[Docket No. FAA-2023-0163; Project Identifier AD-2022-01380-T; Amendment 39-22468; AD 2023-12-10]

Airworthiness Directives; The Boeing Company Airplanes

ACTION: Final rule.

Figure 1 to paragraph (g)(2)(i)—Fundamental Effective Isotropic PSD at Outside Interface of Aircraft Antenna

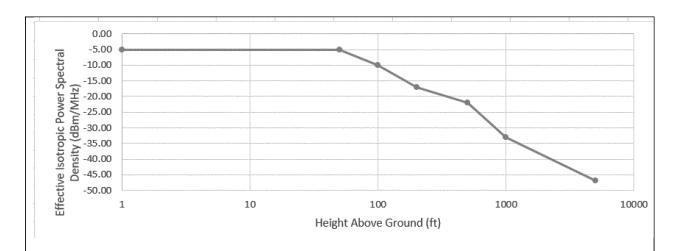
- (1) For purposes of this AD, a "5G C-Band mitigated airport" (5G CMA) is an airport at which the telecommunications companies have agreed to voluntarily limit their 5G deployment at the request of the FAA, as identified by an FAA Domestic Notice.
- (2) For purposes of this AD, a "radio altimeter tolerant airplane" is one for which the radio altimeter, as installed, demonstrates the tolerances specified in paragraphs (g)(2)(i) and (ii) of this AD, using a method approved by the FAA.
- (i) Tolerance to radio altimeter interference, for the fundamental emissions (3.7–3.98 GHz), at or above the power spectral density (PSD) curve threshold specified in figure 1 to paragraph (g)(2)(i) of this AD.

Figure 2 to paragraph (g)(2)(ii)—Spurious Effective Isotropic PSD at Outside Interface of Aircraft Antenna

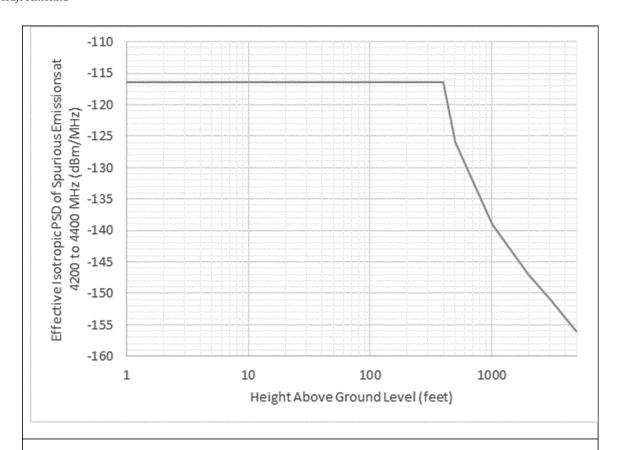
(ii) Tolerance to radio altimeter interference, for the spurious emissions (4.2–

4.4 GHz), at or above the PSD curve threshold

specified in figure 2 to paragraph (g)(2)(ii) of this AD.
